MEMORANDUM

DATE: November 9, 2000

FROM: Barry Chen, P.E., Hart Crowser

**RE: Stability Review of RECo 30% Design
Third Runway Embankment Project
J-4978-30**

Description: West Wall Stability
Comments: STA 186+00 60% Design Pseudostatic (Block)
File Name: 186+0060%475fs.slp
Last Saved Date: 9/25/00
Last Saved Time: 4:46:19 PM
Analysis Method: Spencer
Seismic Coefficient: Horizontal

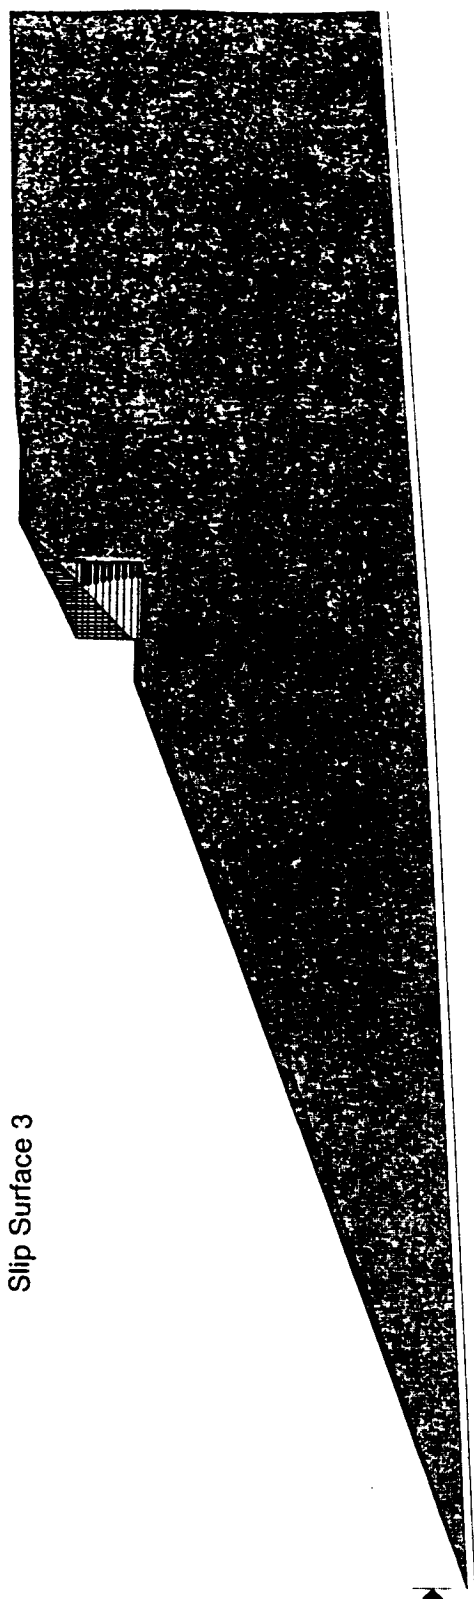
- Station 186+00 (West Wall),
- Station 142+75 (South Wall), and
- Station 147+25 (South Wall).

In the September 28, 2000, review meeting, we suggested increasing the thickness of steel strips from 50x4 mm to 50x6 mm in the upper tier to address the compound stability issue. We also suggested increasing the embedment depth and/or strip length to address the global stability at Station 147+25. Our follow up analyses indicated that increasing the strip thickness would yield satisfactory factors of safety for compound stability in all cases. For Station 147+25 (South Wall), our analyses indicated that increasing the embedment depth and strip length by 2 feet would yield satisfactory factors of safety for global stability.

We performed FLAC analyses on Station 186+00 (West Wall) and Station 147+25 (South Wall) that incorporate the proposed design modifications. The results indicated that stresses in steel strips did not exceed the allowable tensile strength. Maximum deformations at the end of a 475-year seismic event are summarized as follows:

Horizontal: 10 inches at top of wall
Upward: 6 inches at toe of wall
Downward: 4 inches at top of embankment behind MSE wall

#	Design Scenario	Target FS	Surface 1 (cir)	Surface 2 (blk)	Surface 3 (blk)	Surface 4 (blk)	Surface 5 (cir)	Surface 6 (cir)
1	Steady state (Spencer)	1.5	1.73	1.50	1.51	1.65	1.54	1.57
2	Pseudostatic, 475-yr event (Spencer)	1.1	1.18	1.13	1.03	1.09	1.09	1.12
2a	Pseudostatic, 475-yr event (Spencer) with 50x6mm steel	1.1			1.89

Description: South Wall 147+25 (HC 147+50 or F-F')
Comments: 60% Design - Pseudostatic Global (Circle)
File Name: 147+2560%475globc.slp
Last Saved Date: 9/26/00
Last Saved Time: 1:35:42 PM
Analysis Method: Spencer

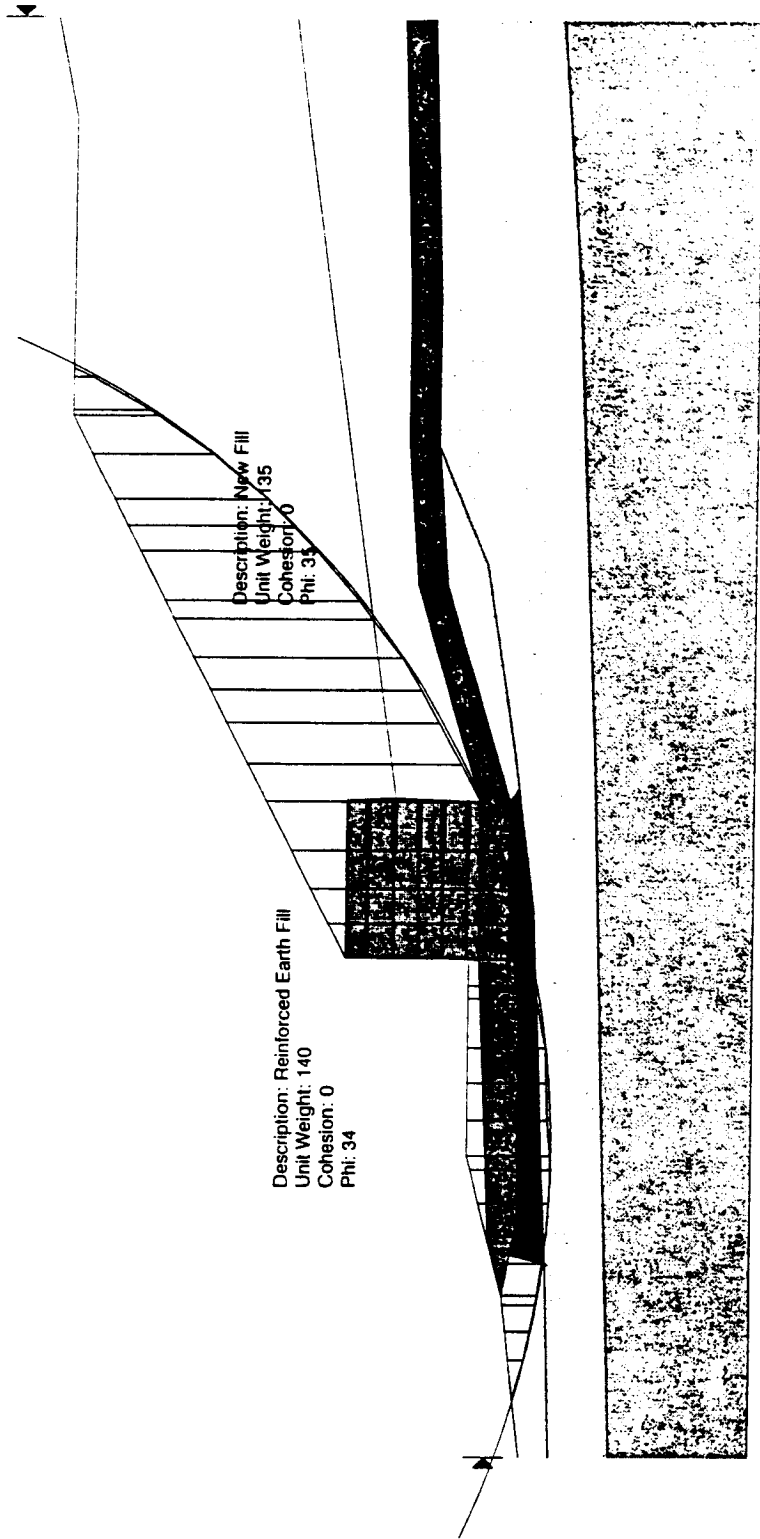
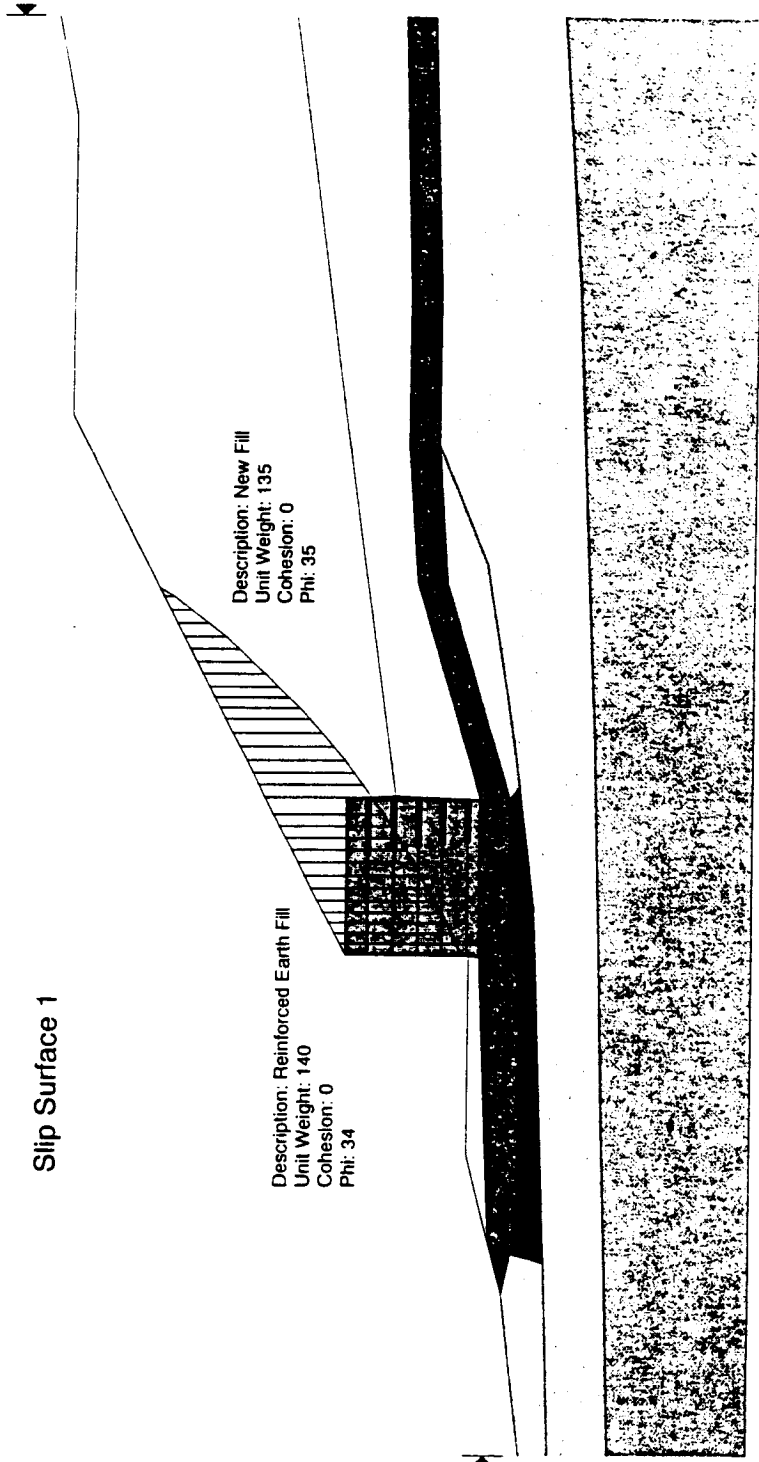
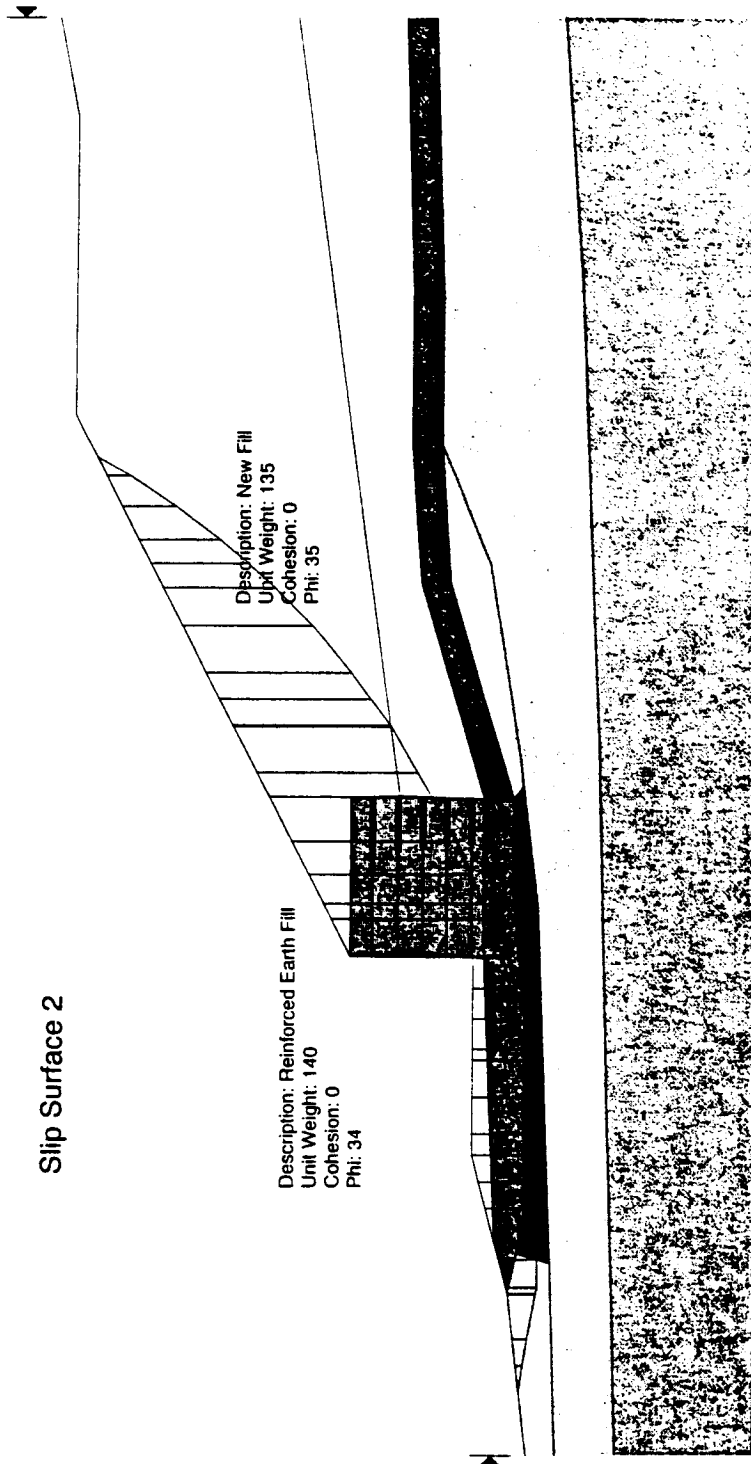
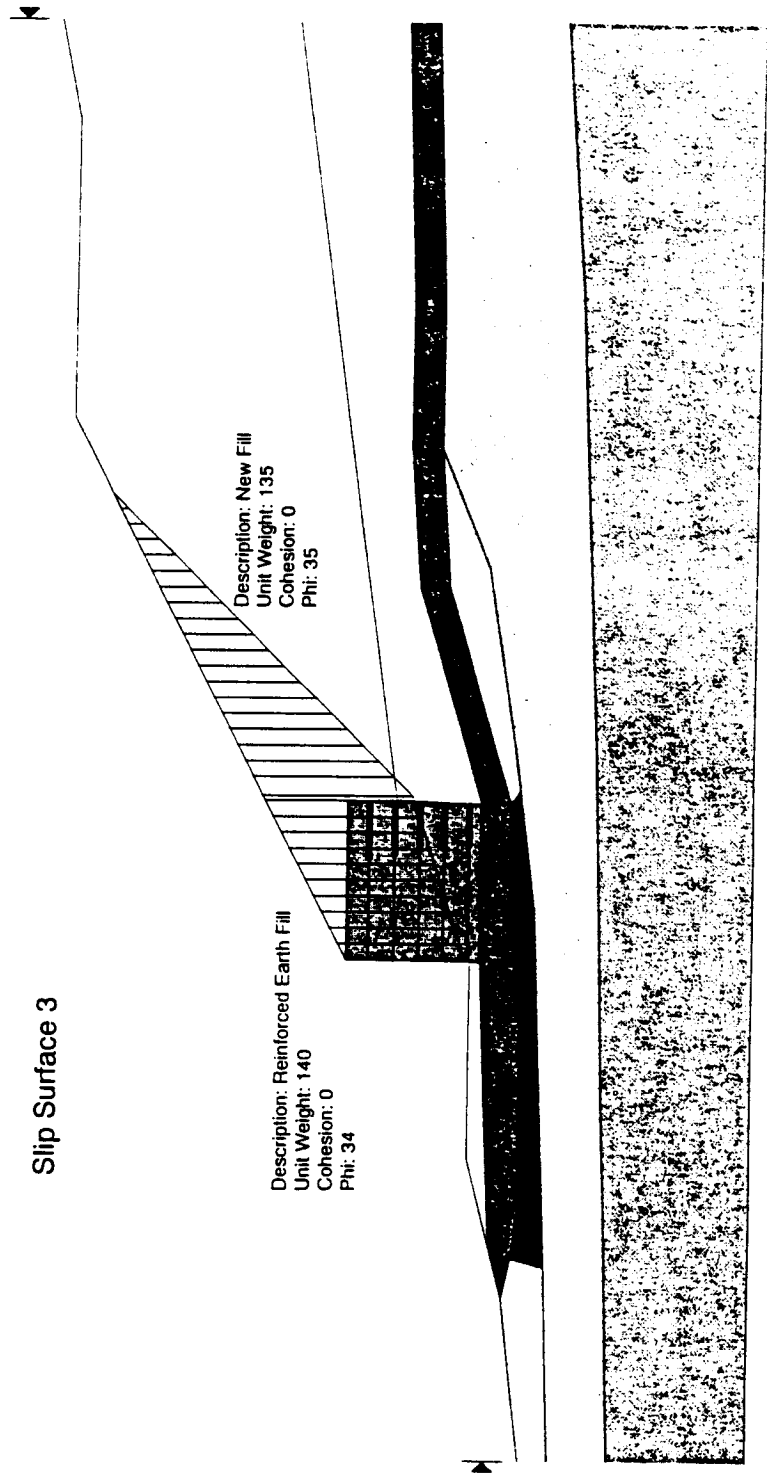
We also found marginal factors of safety for global stability in Station 147+25 (South Wall).

Horizontal: 14 inches at top of wall
Upward: 9 inches at toe of wall
Downward: 5 inches at top of 2:1 slope

#	Design Scenario	Target FS	Surface 1 (cir)	Surface 2 (cir)	Surface 3 (blk)	Surface 4 (blk)	Surface 5 (blk)	Surface 6 (cir)
1	Steady state (Spencer)	1.5	1.37	1.47	1.39	1.53	1.50	1.49
1a	Steady state (Spencer) w/ 50x6mm steel	1.5	1.71	1.54	1.53			1.65
2	Pseudostatic, 475-yr event (Spencer)	1.1	0.95	1.01	1.01	1.16	1.09	1.03
2a	Pseudostatic, 475-yr event (Spencer) w/ 50x6mm steel	1.1	1.14	1.05 (see below)	1.09		1.17	1.12

COMPOUND - SURFACE 2 (STEEL INCREASED TO 50x6 mm)

Embedment (feet)	Strip length (feet)	Pseudostatic FS (Spencer)
1	16 (design)	1.054
2	16	1.06
1	17	1.067
2	17	1.072
1	18	1.077
2	18	1.083

GLOBAL - CIRCULAR FAILURE (STEEL INCREASED TO 50x6mm)

Embedment (feet)	Strip length (feet)	Steady-State FS	Pseudostatic FS
1	16 (design)	1.51	1.06
1	17	1.54	1.08
2	18	1.63	1.20

Figure 1. FLAC Grid

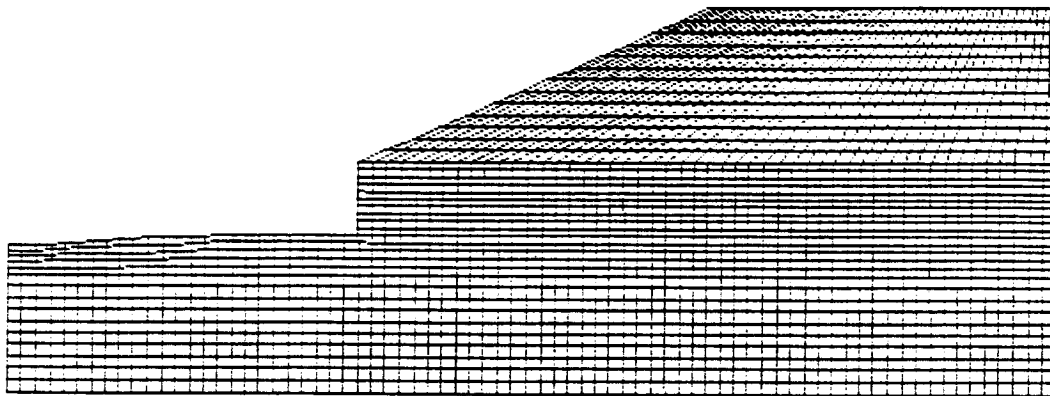
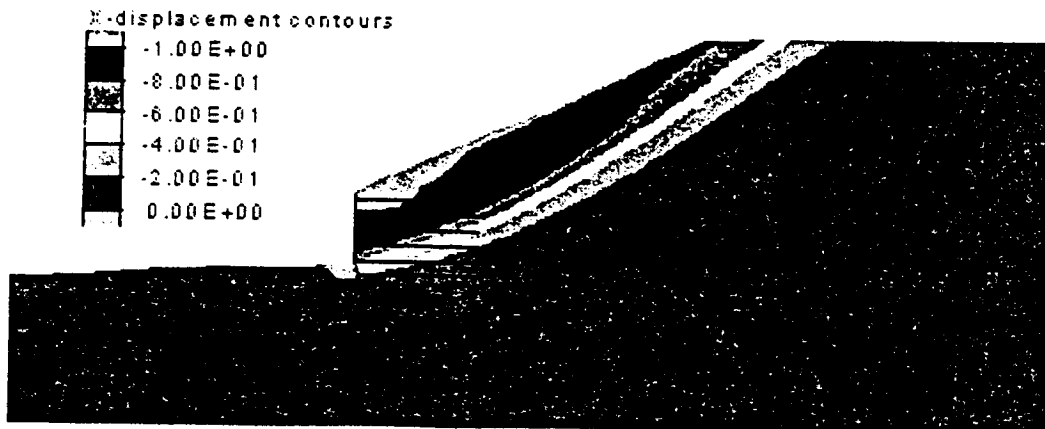
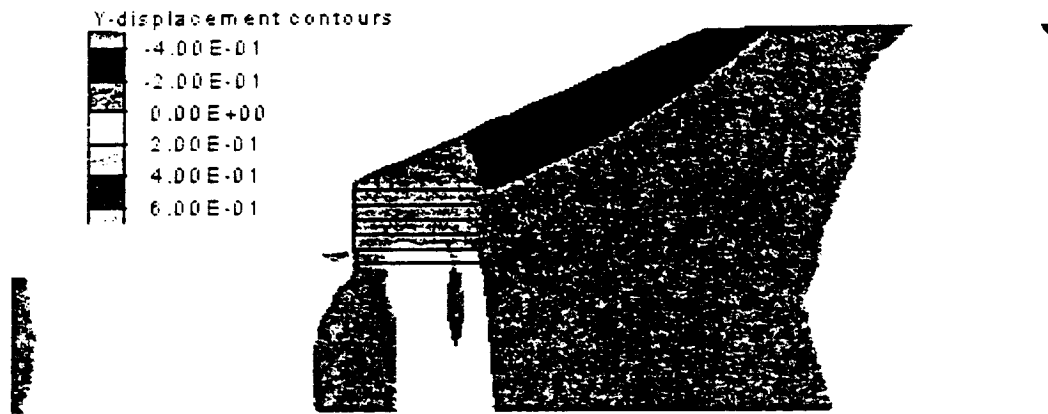
As a check of the slope stability analyses, which indicated low stability under a seismic event, the FLAC analyses were set up to model the recommended changes that bring the seismic slope stability up to a higher level of stability. Changes to the RECo design were as follows:

1. Increase the wall embedment 2 feet;
2. Add one layer of reinforcement below the wall;
3. Increase all reinforcement lengths from 16 feet to 18 feet; and
4. Change reinforcement thickness from 4mm to 6mm.

After static construction of the model it was subjected to a synthetic earthquake motion. The maximum seismic (end of shaking) horizontal displacement was just less than 14 inches just above the top of the wall on the toe of the 2H:1V slope. Figure 5 illustrates the distribution of seismic horizontal displacements throughout the model. The maximum seismic (end of shaking) downward vertical displacement was just less than 5 inches at the top of the 2H:1V slope above the wall. There was upward vertical displacement at the toe of the wall of just more than 9 inches. Figure 6 illustrates the distribution of seismic vertical displacements throughout the model. The maximum stresses in the reinforcement were monitored throughout the earthquake and are shown in Table 5. The maximum stress in the reinforcement was calculated to be in the base layer of reinforcement at the wall face. In general, the maximum seismic stresses were much larger than the static stresses in the reinforcement. However, the yield strength was not reached in the analysis.
